Iowa DAS - DOC 4JD CBC New Central Office Building

Addendum #01

Dated: April 30, 2026

ADDENDUM NUMBER ONE
To Contract Documents for:
IOWA DAS – DOC 4JD CBC NEW CENTRAL OFFICE BUILDING
SVPA Project No. 25079
Owner Project No. 9488.00

LANDSCAPING PLAN

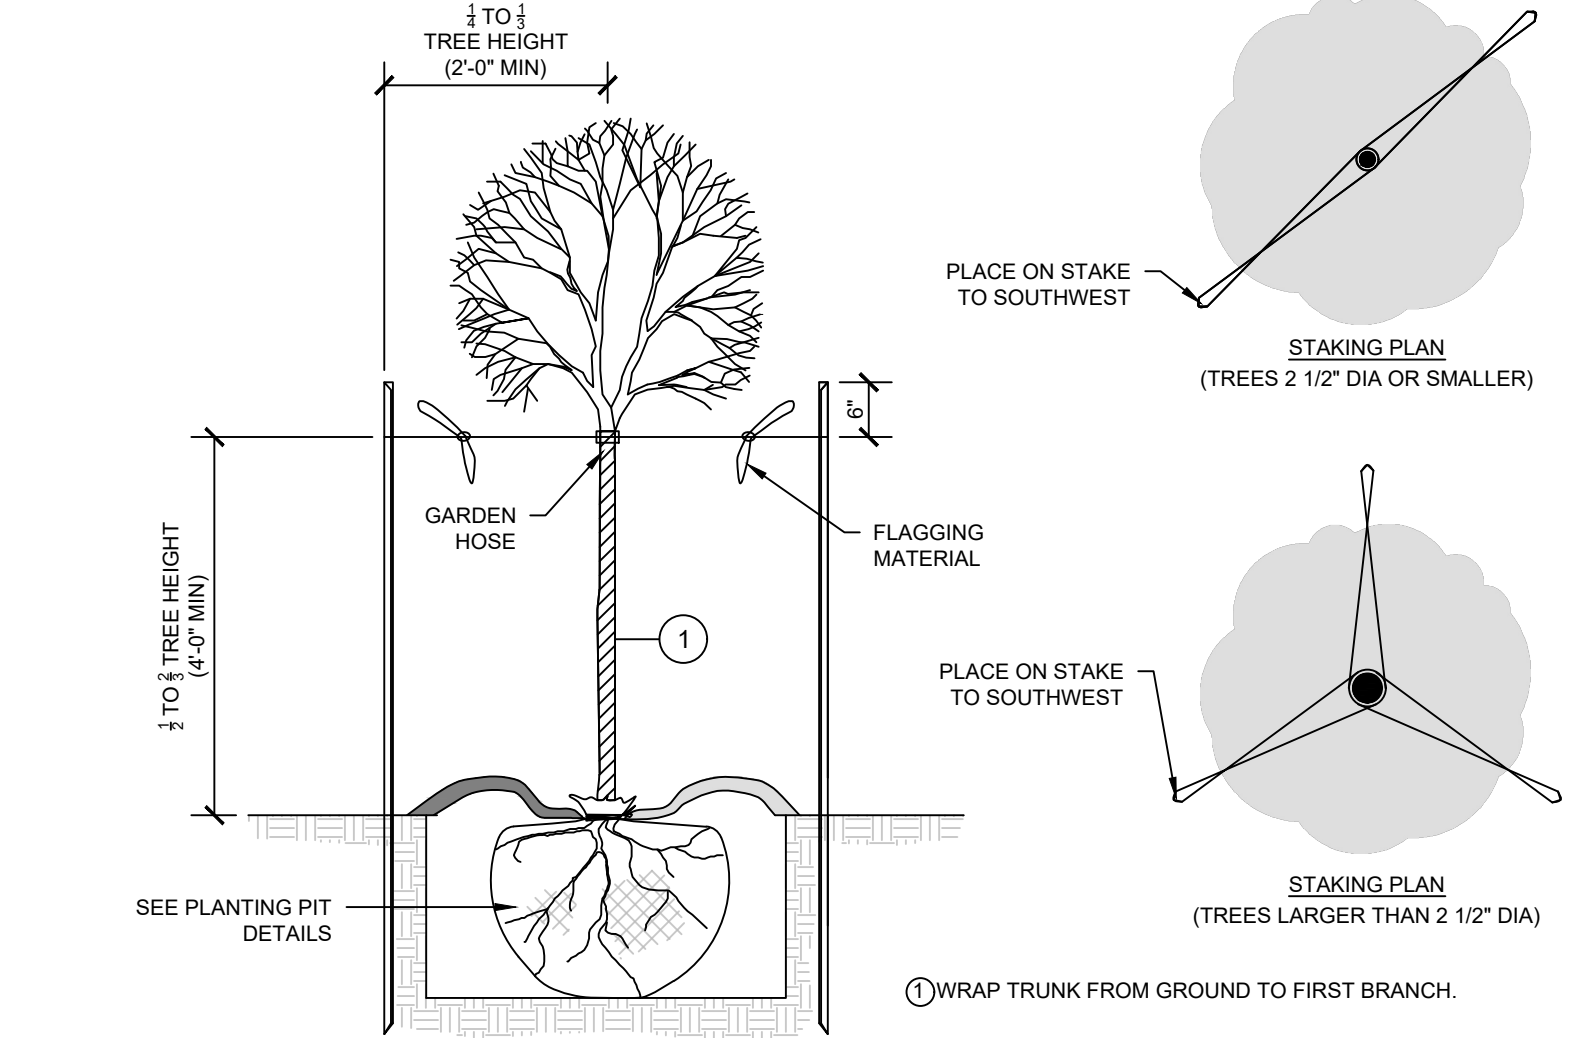
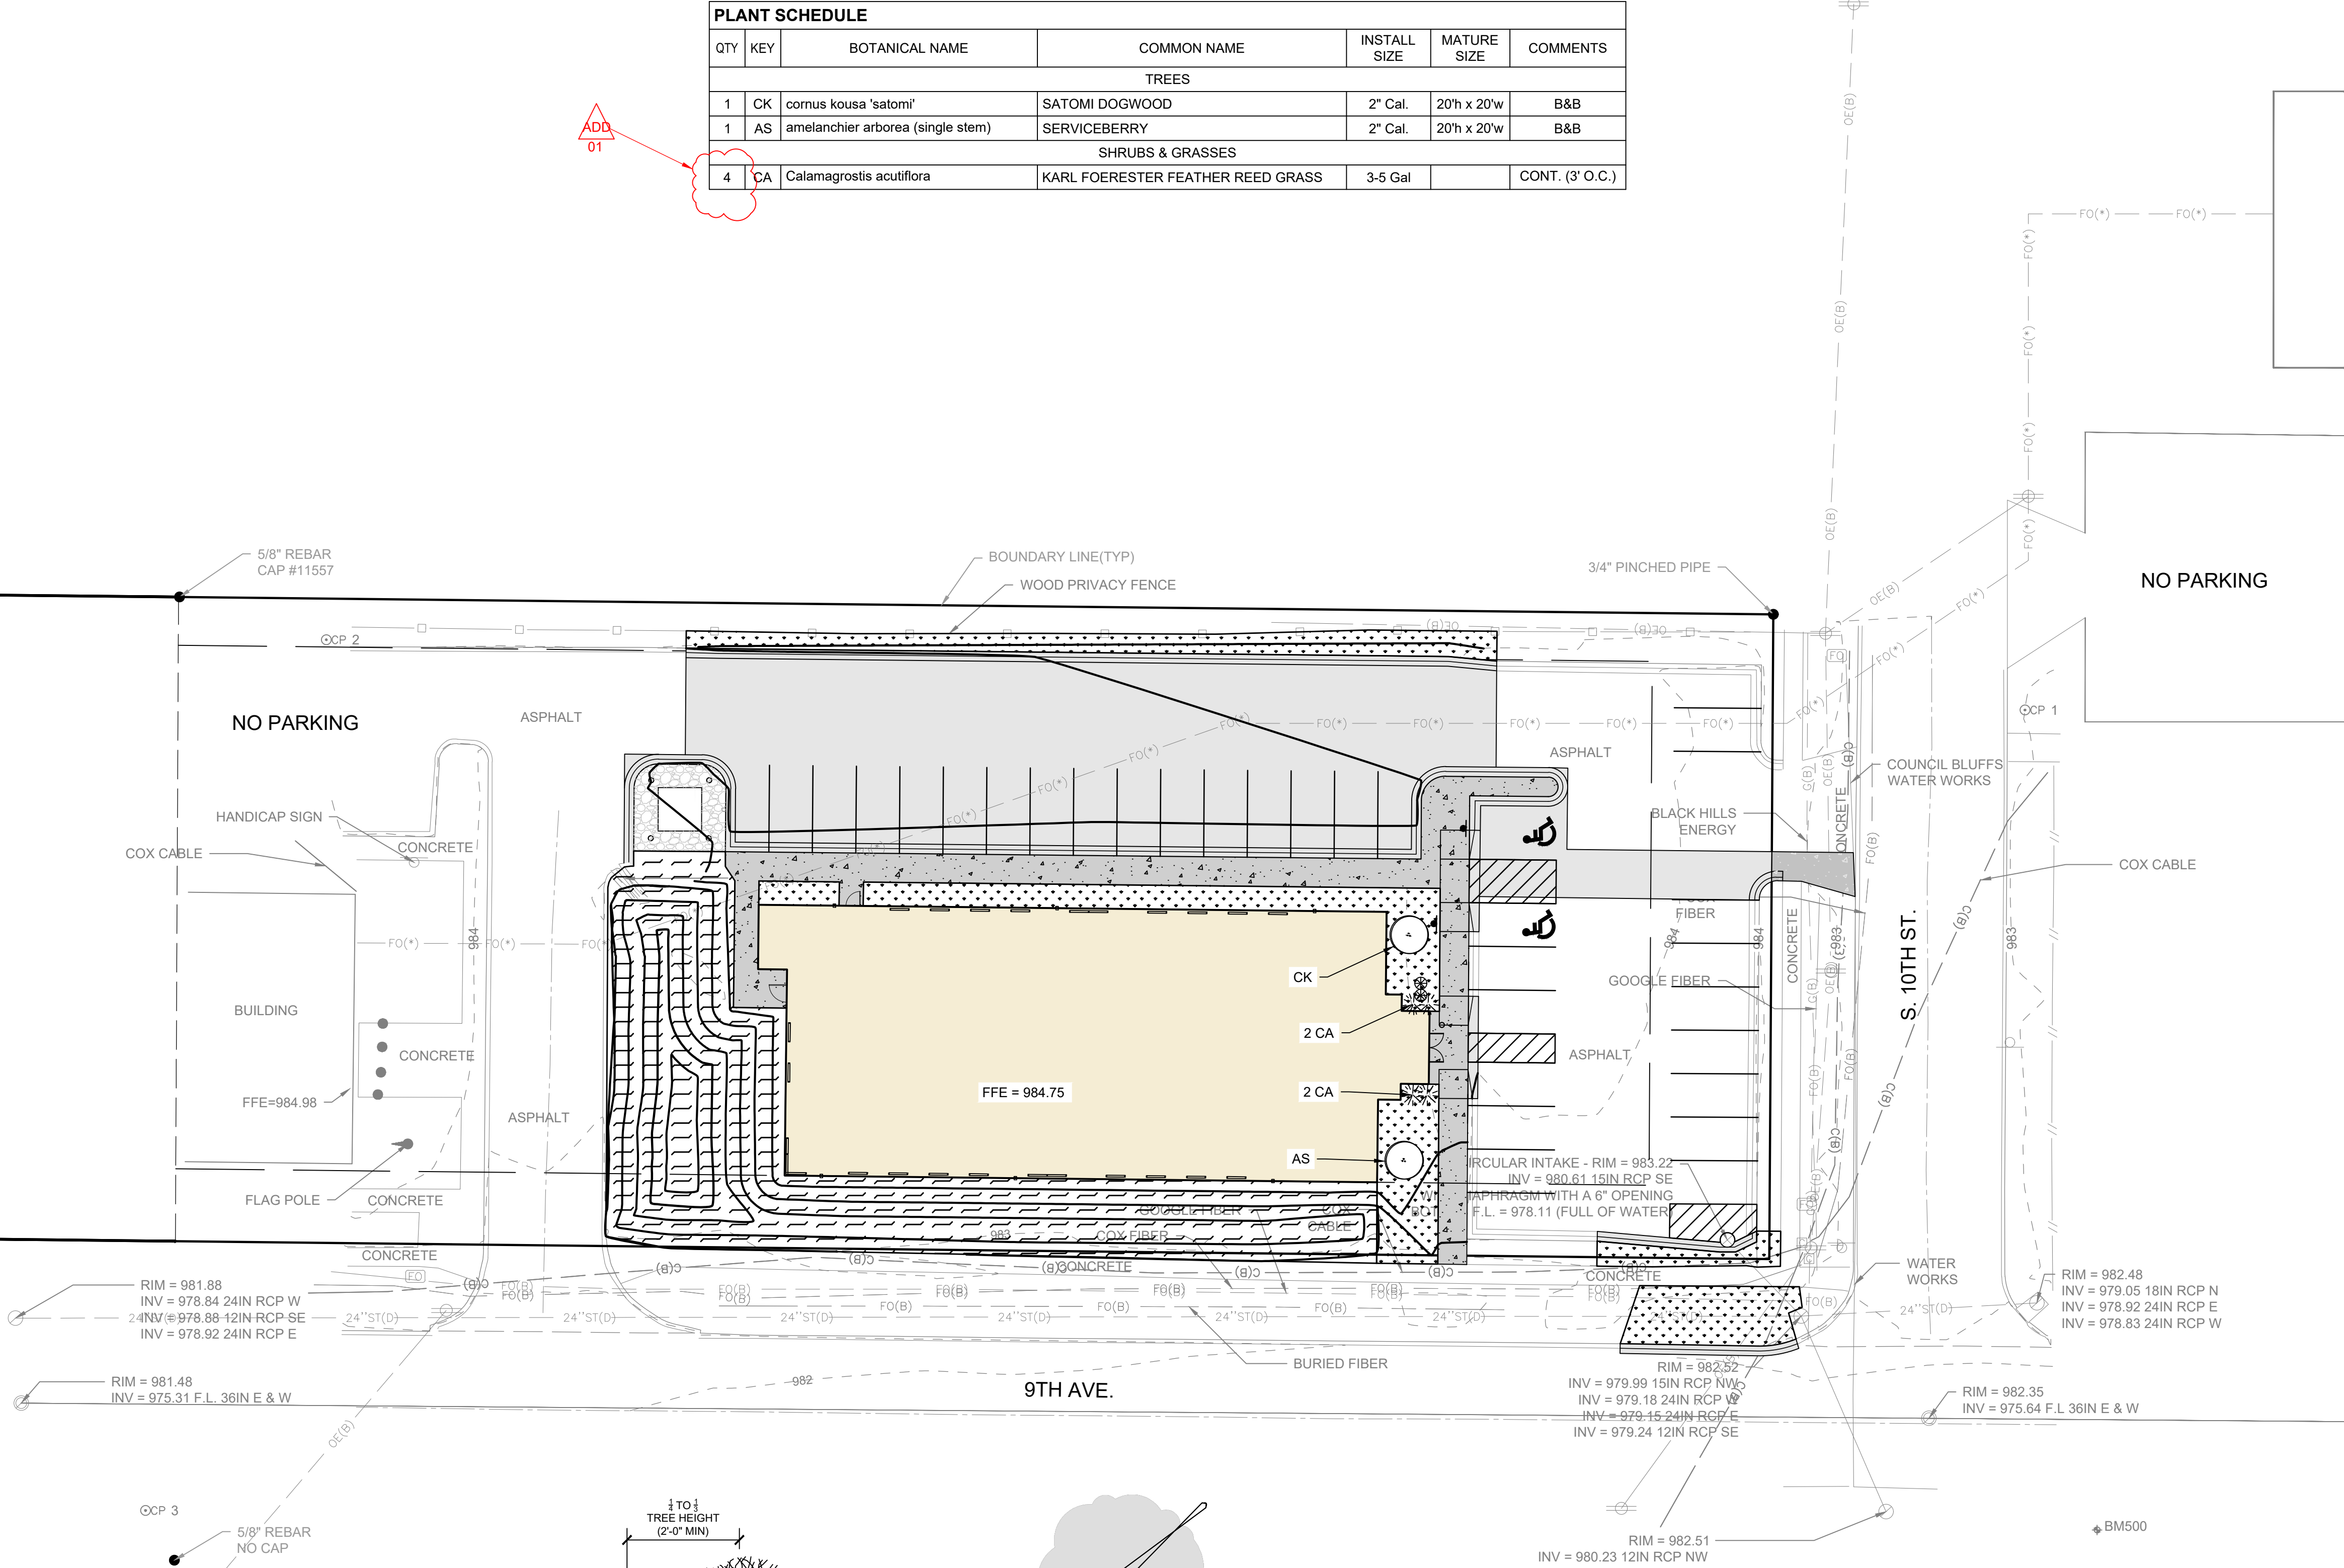
- A. REVISE note 4F.
 - B. See attached revised sheet C4.
4. **Sheet C10 – LANDSCAPING PLAN**
 - A. REVISE plant schedule table.
 - B. See attached revised sheet C10.

FLOOR PLANS

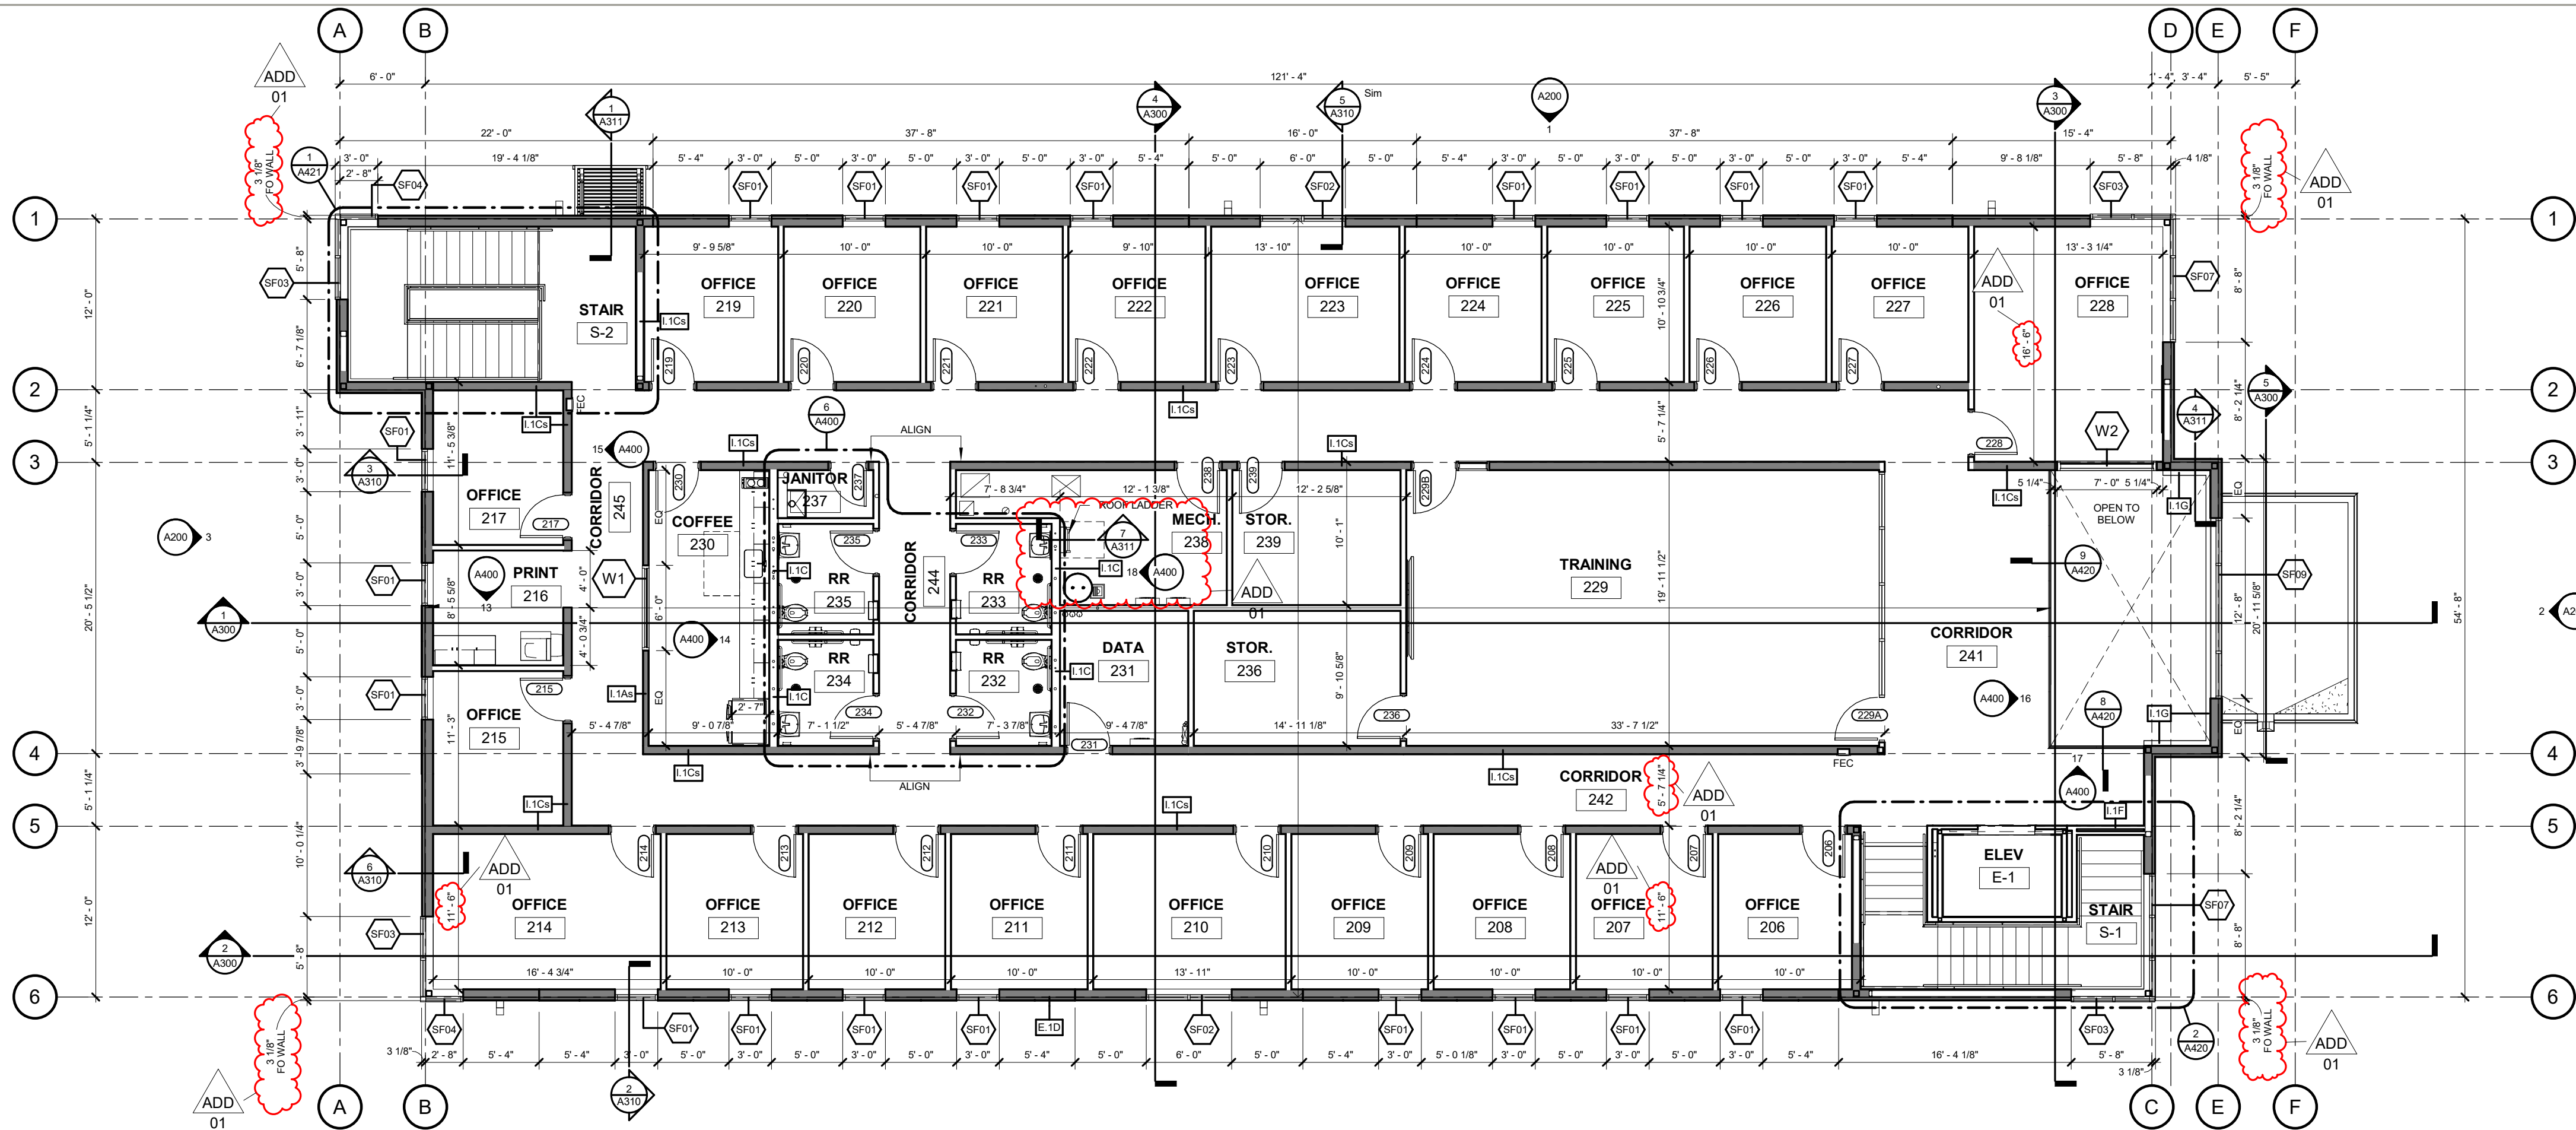
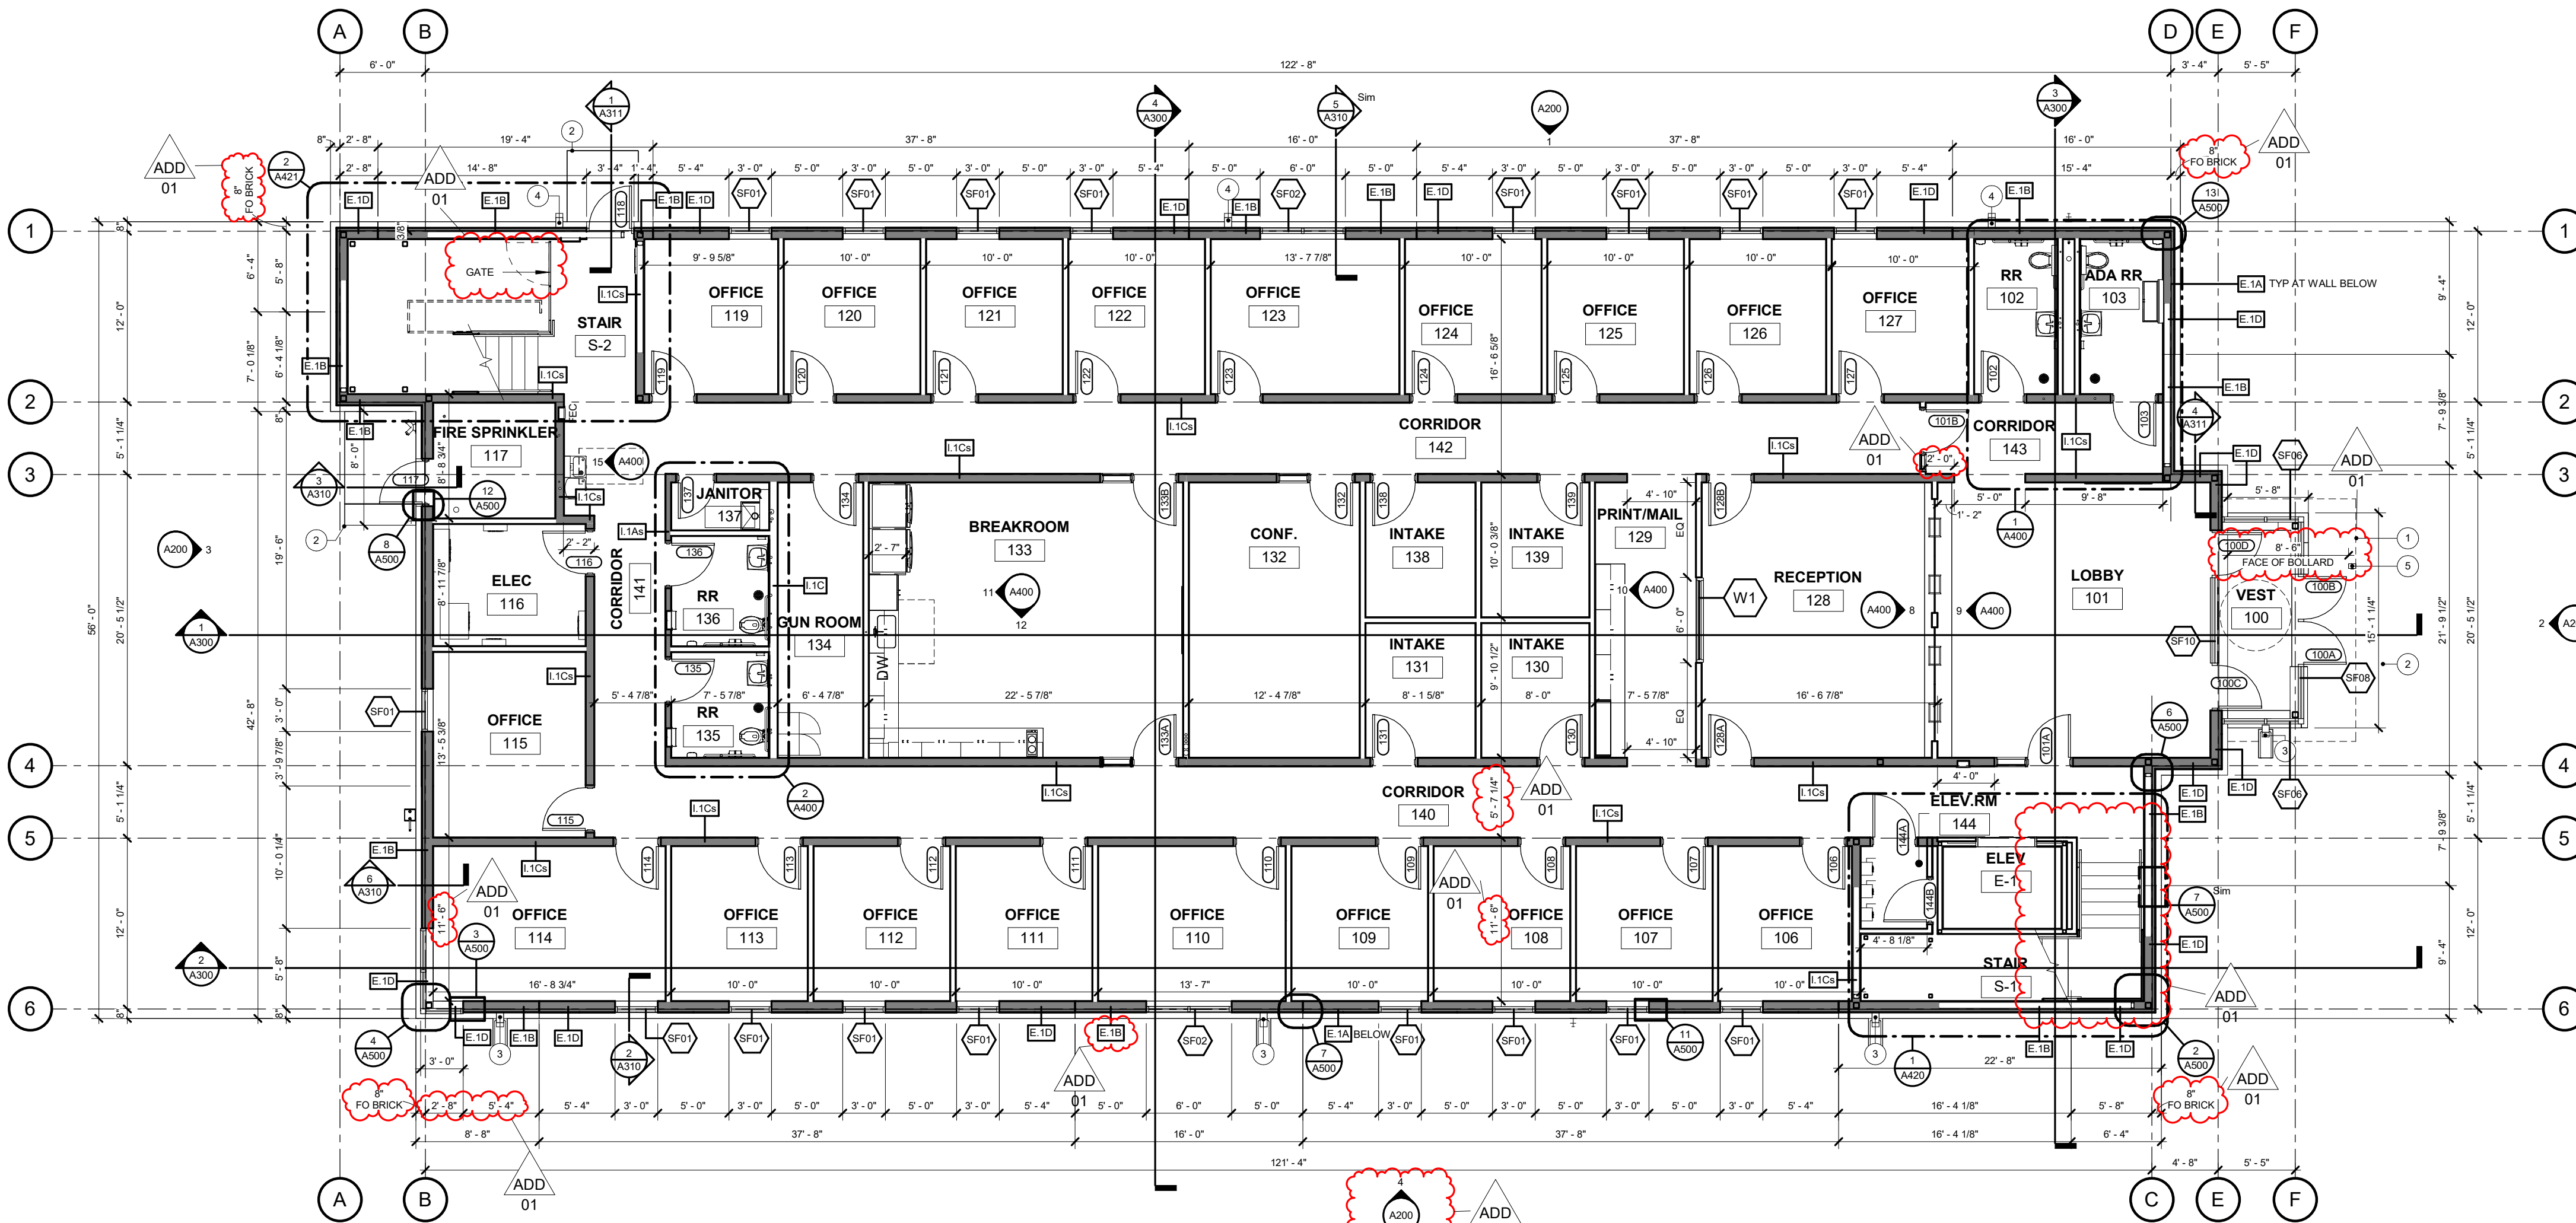
7. **Sheet A100 – FLOOR PLANS**
 - A. ADD dimension strings and clarifying notes to dimension string at building corners.
 - B. ADD section 7/A311 and elevation 18/A400 to Mechanical Room 238.

- C. REVISE elevation in GENERAL NOTES: FLOOR PLANS note 3.
 - D. See attached revised sheet A100.
8. **Sheet A110 – ROOF PLAN**
 - A. ADD Keynotes to ROOF PLAN NOTES.
